2026 Public Right-of-Way Bureau Specification and Detail,

Summary of Changes

CURB AND SIDEWALK CONSTRUCTION SPECIFICATIONS

February 2026

5 SIDEWALK ADDITION DUE TO OBSTRUCTION
SCALE: NONE

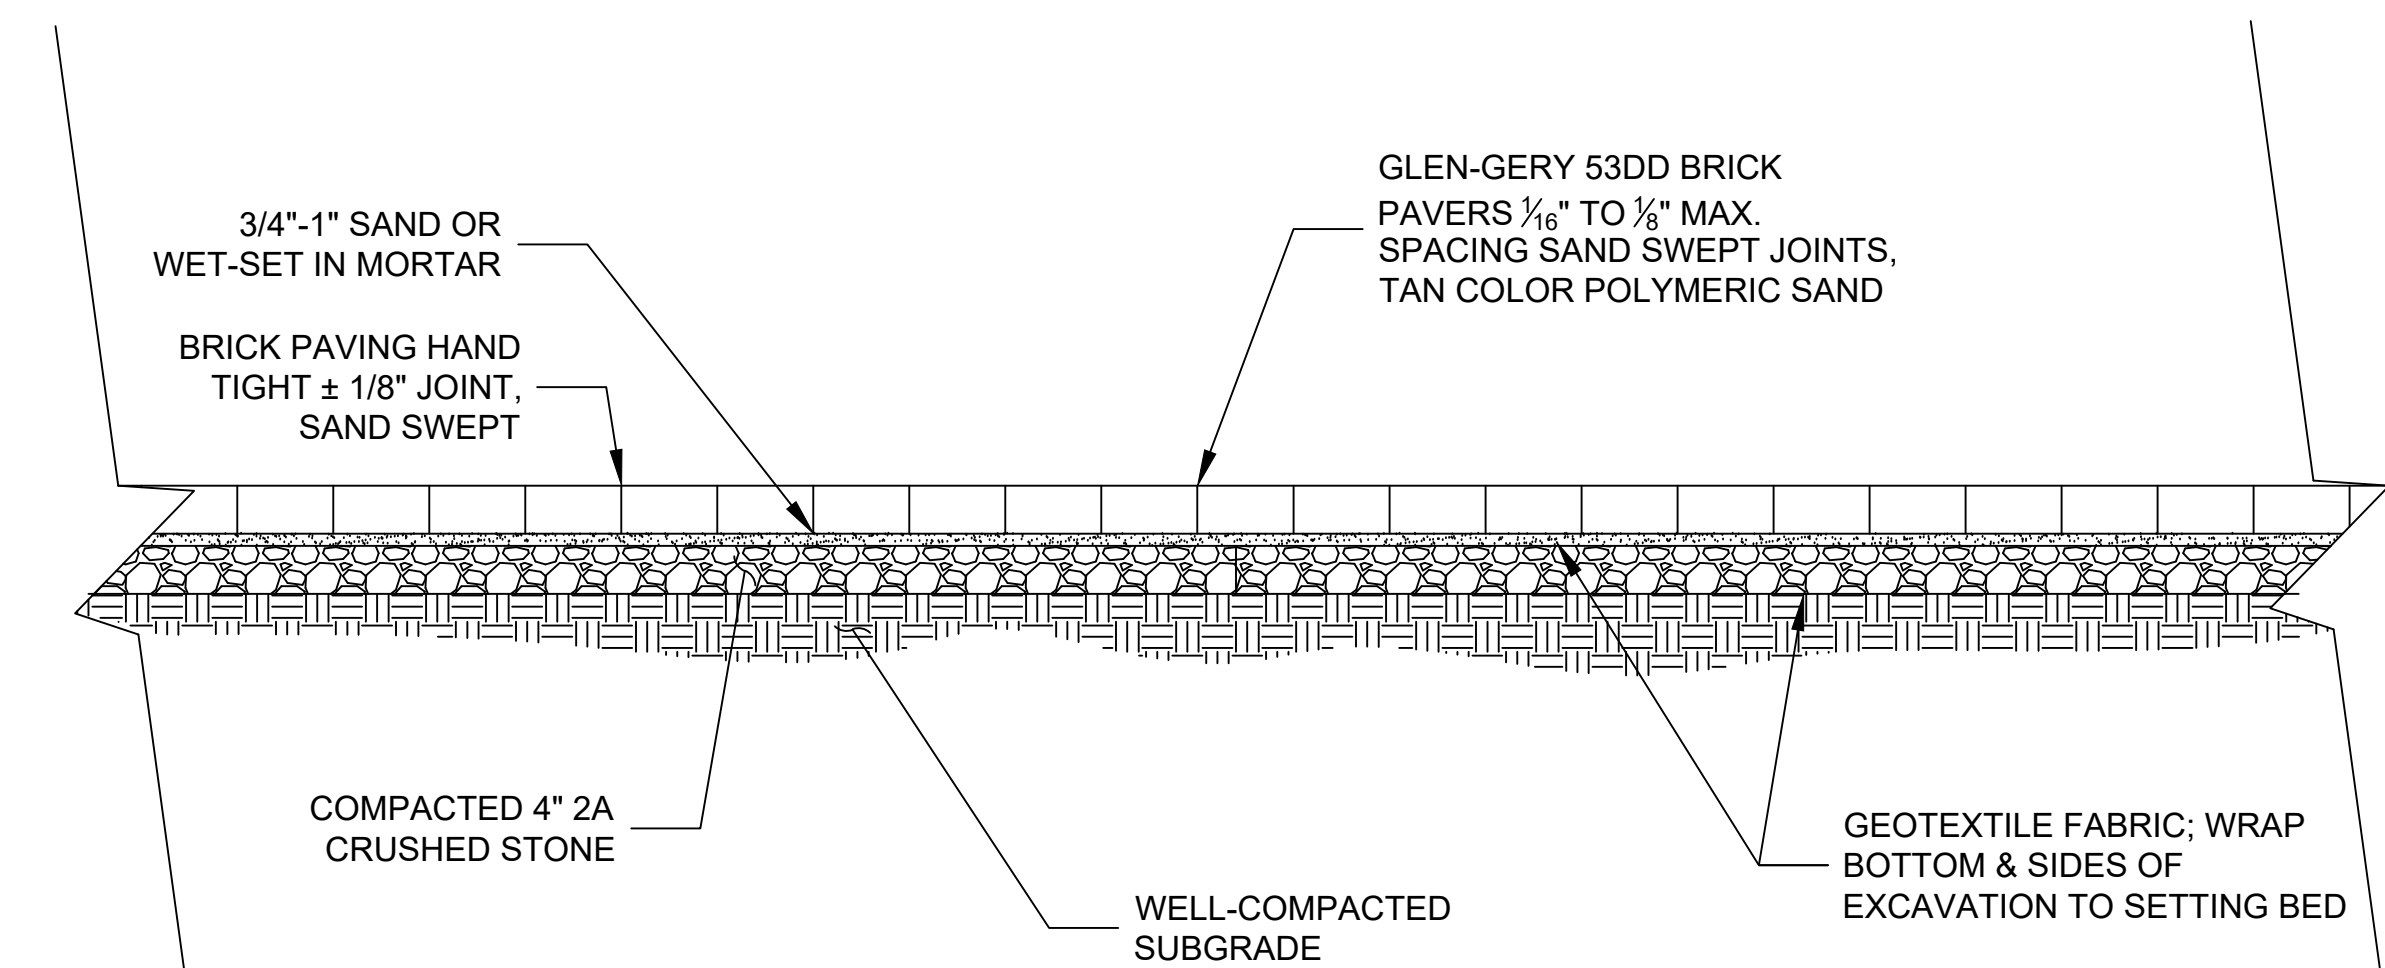
- **Curb and Sidewalk Details**
 - Detail 5, Sheet 1 was added to show a sidewalk addition as a result of an obstruction in the sidewalk.
 - Monument box detail was moved to Sheet 3 for clarity.

NOTE:
1. CONTINUOUS 4'-0" MIN PEDESTRIAN ACCESS ROUTE REQUIRED AROUND OBSTRUCTION.

10 SIDEWALK DOWNSPOUT DRAIN THROUGH CURB
SCALE: NONE

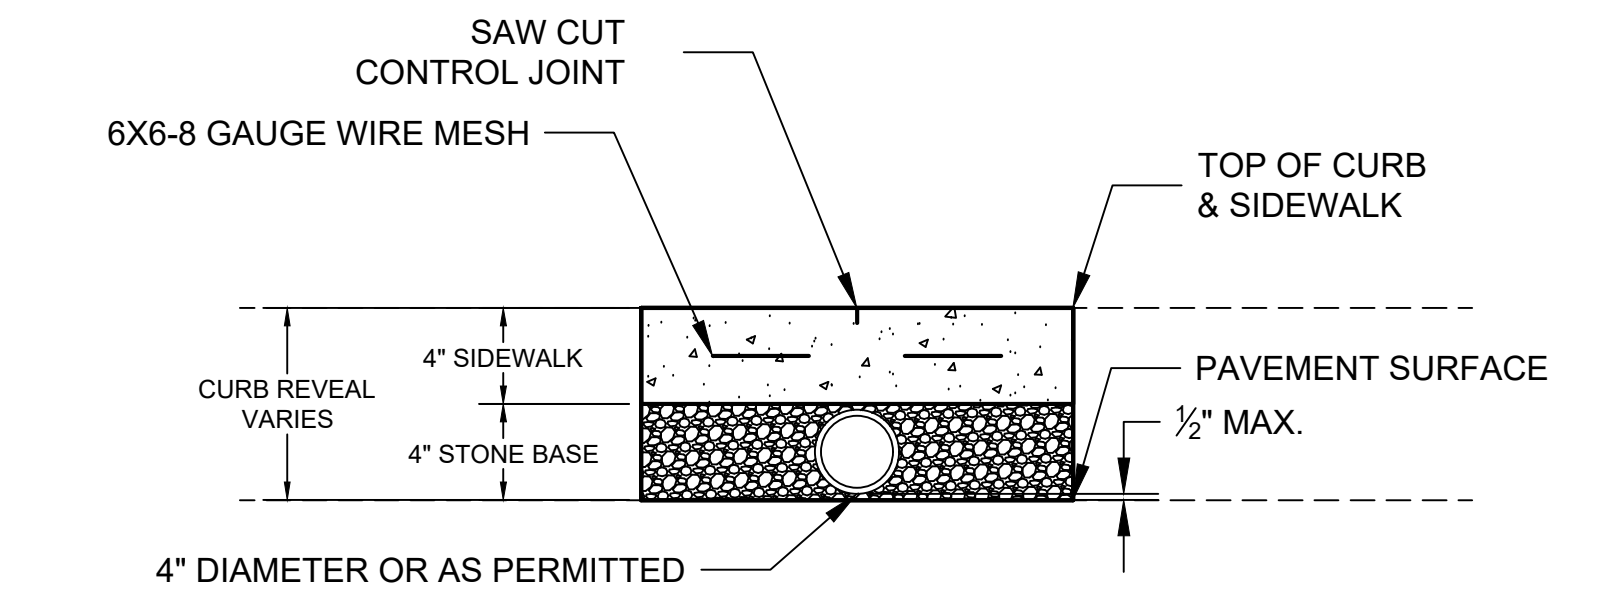
- Detail 10, Sheet 2, Sidewalk Downspout Drain was revised to show the pipe below the sidewalk, the previous detail showed encasement of the pipe in concrete.

2 CURB RAMP WITH PREFORMED THERMOPLASTIC DWS
SCALE: NONE

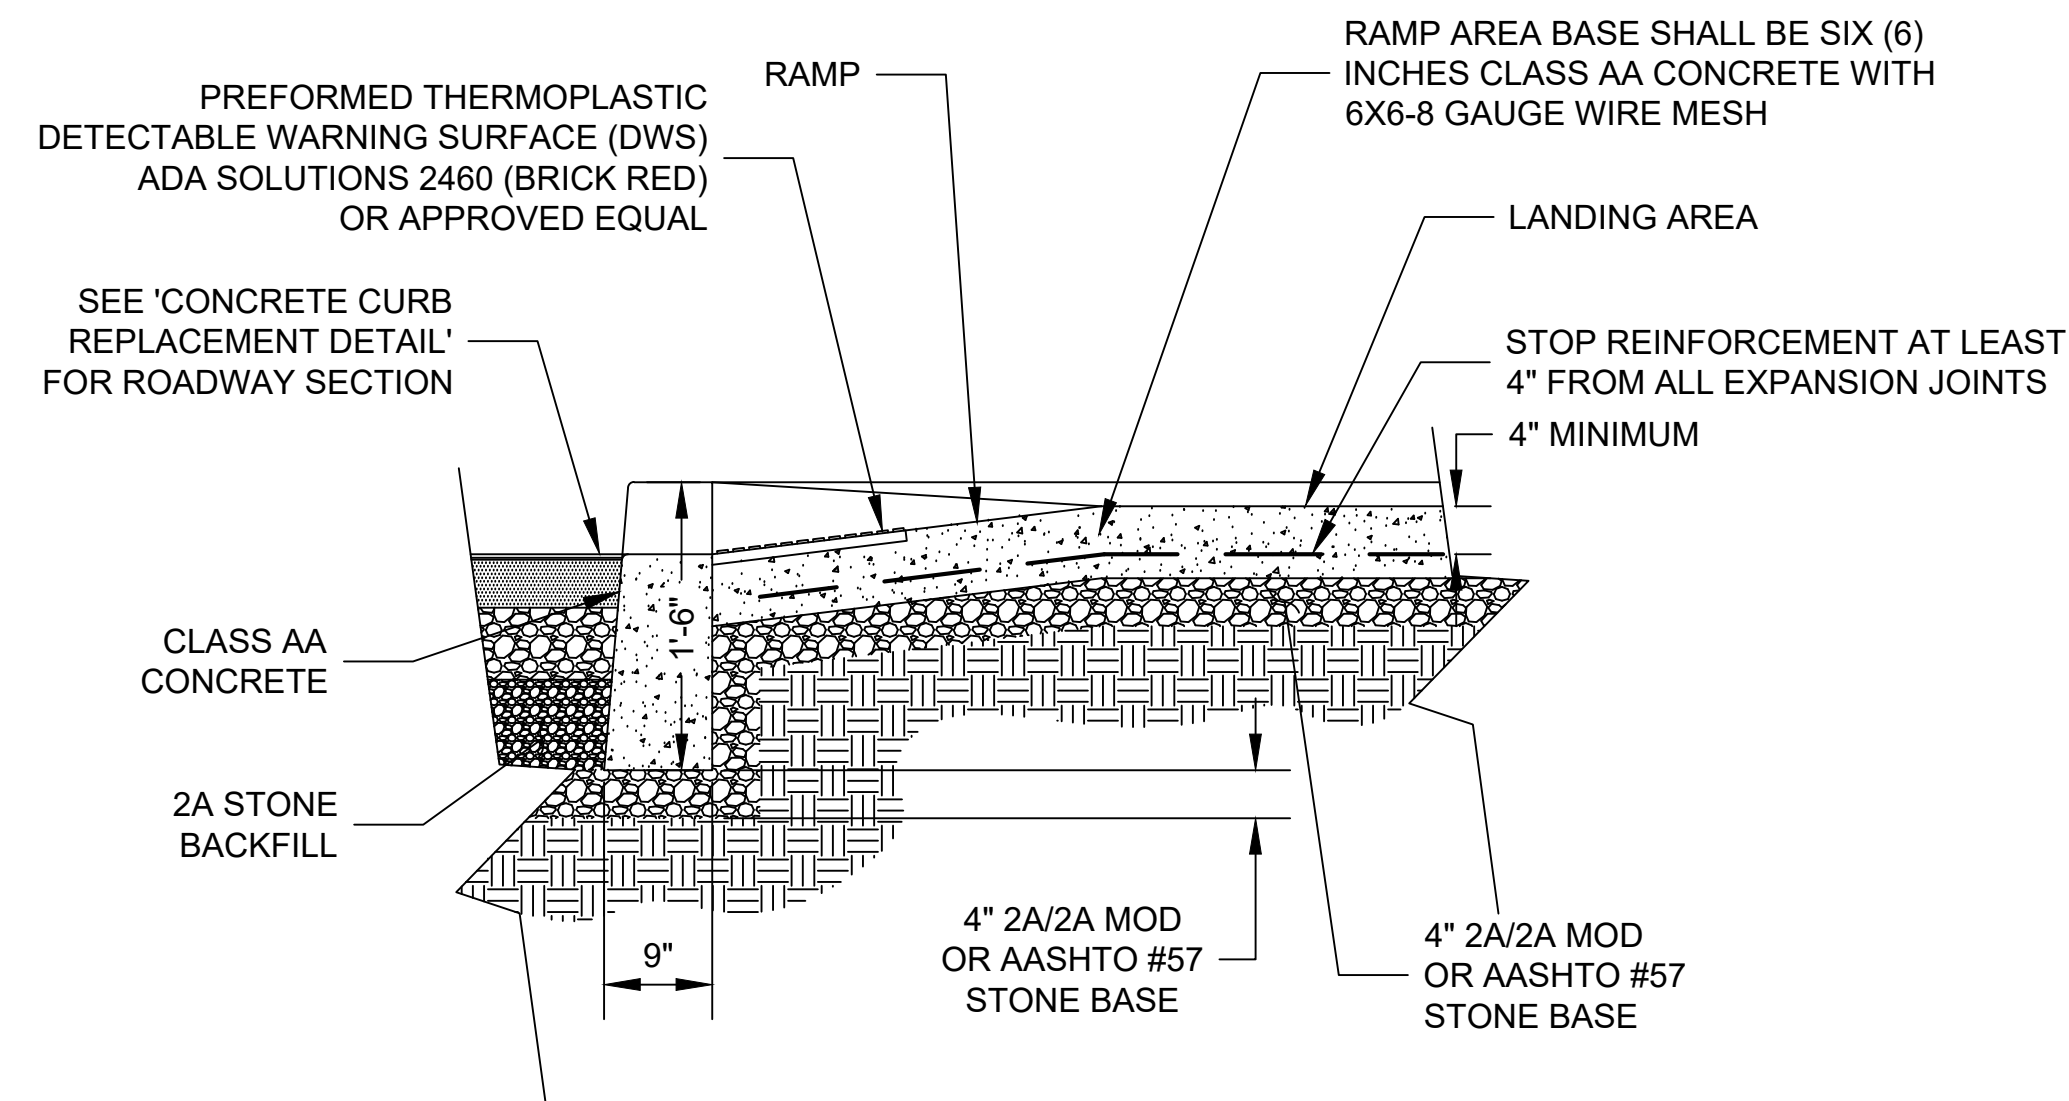
- Detail 2, Sheet 3 was revised to remove requirement that DWS mats be replaceable.
- **Street Details**
 - Detail 1, Sheet 1 was added to show a standard utility trench repair

2 BASE ROADWAY REPAIR DETAIL
SCALE: NONE

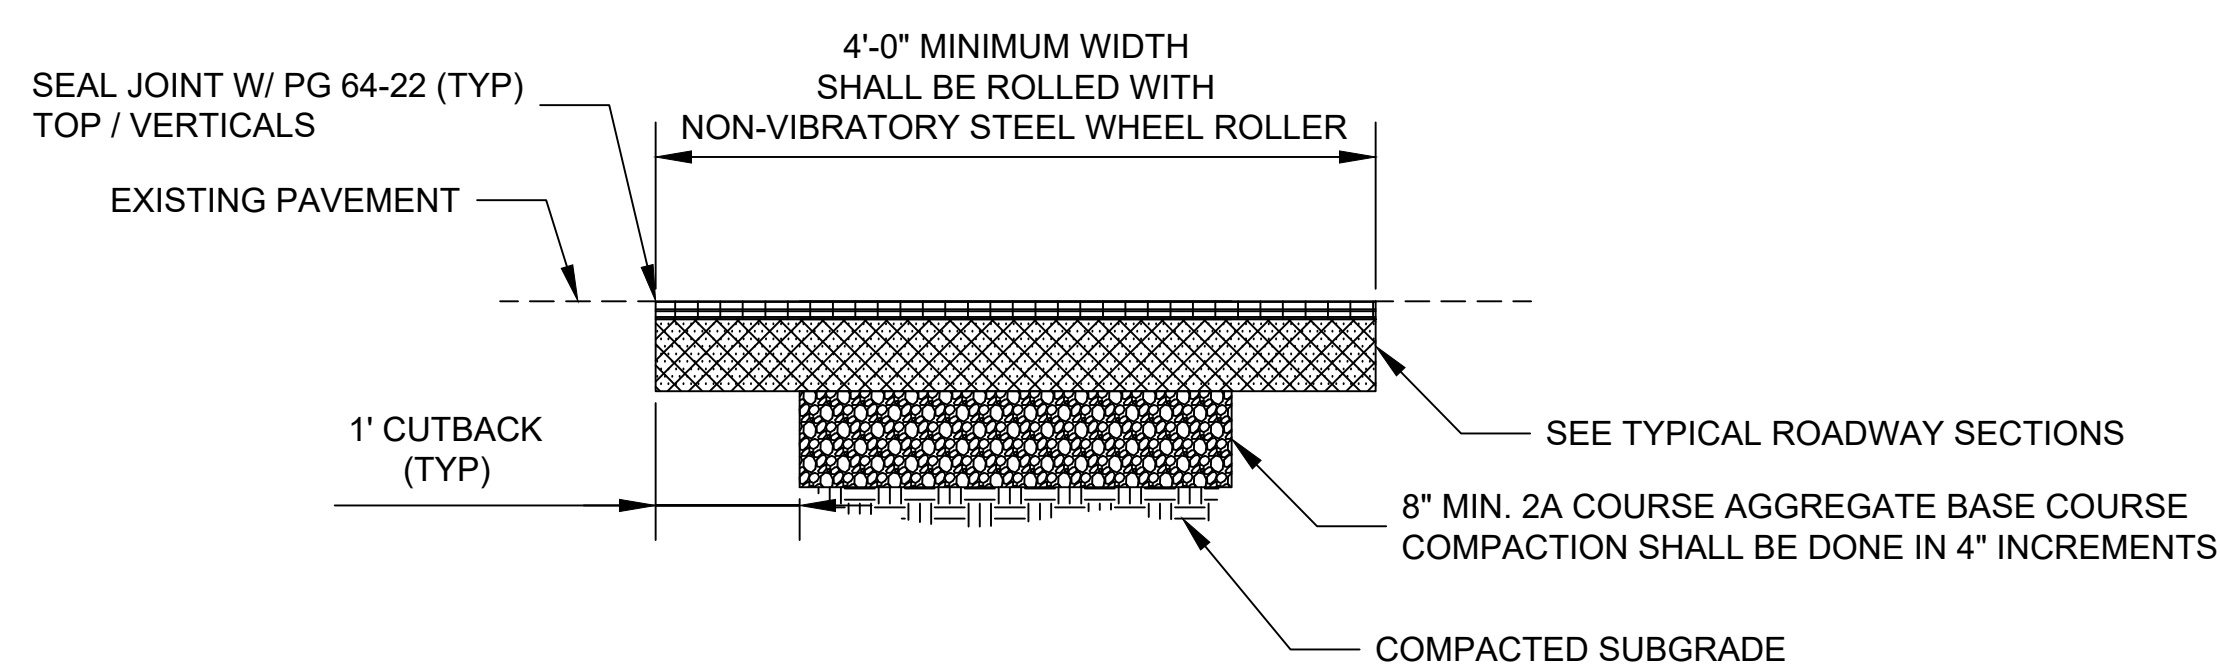
- Detail 2, Sheet 1 was added to show the base repair cross section, specifically including the standard 1ft cutback.
 - Note 6, Sheet 1 was revised to include that pavement compaction testing will be required at the discretion of the Bureau of Engineering.

1 HIGH-VISIBILITY CROSSWALK MARKINGS
SCALE: NONE

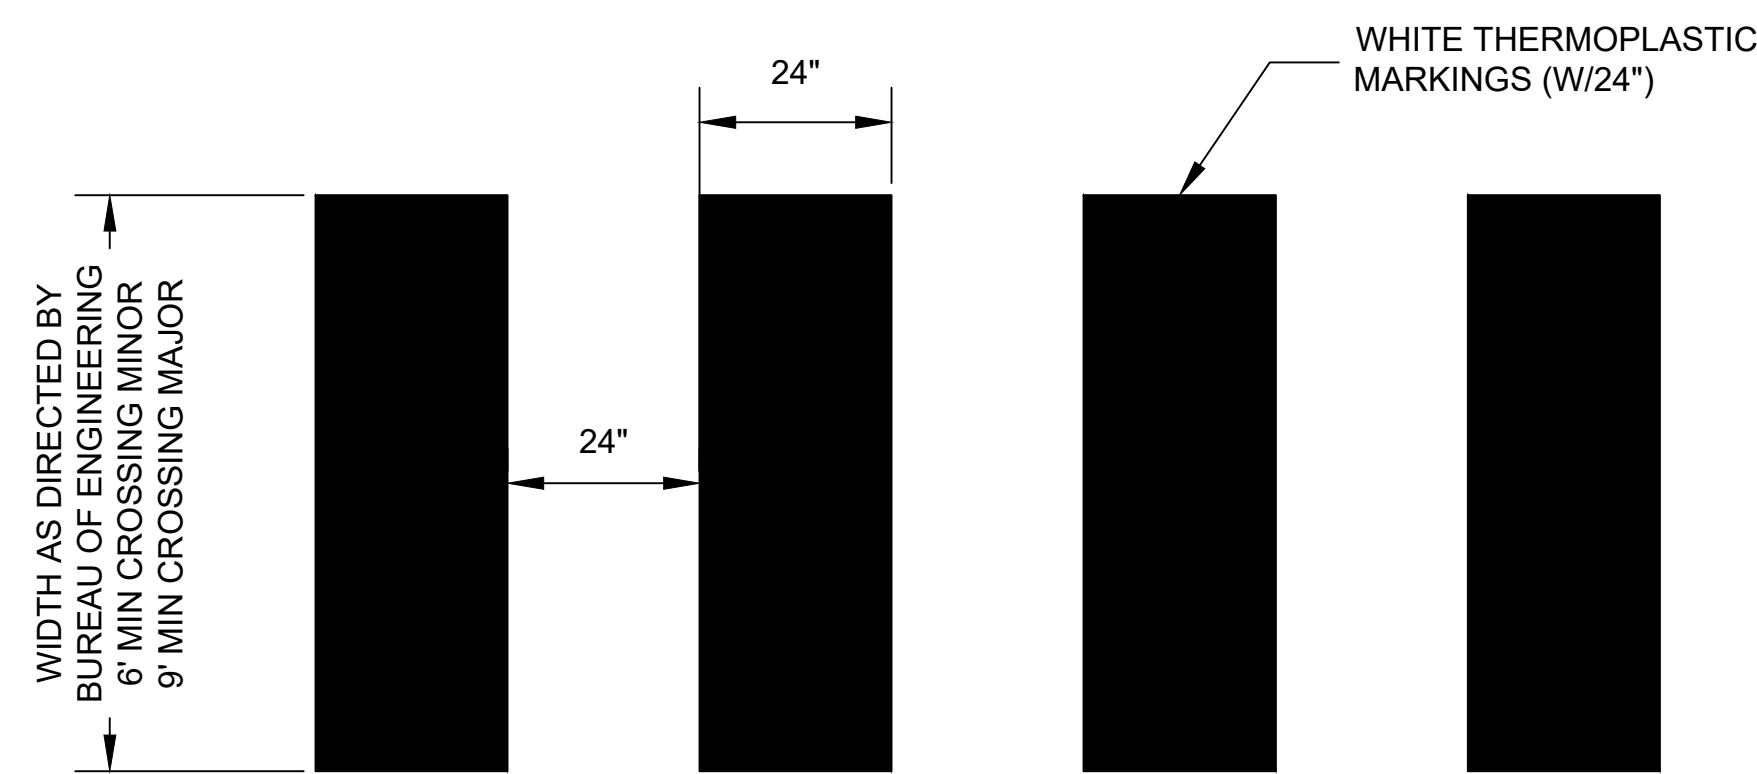
- Details for 'Type 1' and 'Type 2' crosswalks were removed from Sheet 2. Detail 1 was revised to create a uniform crosswalk style.
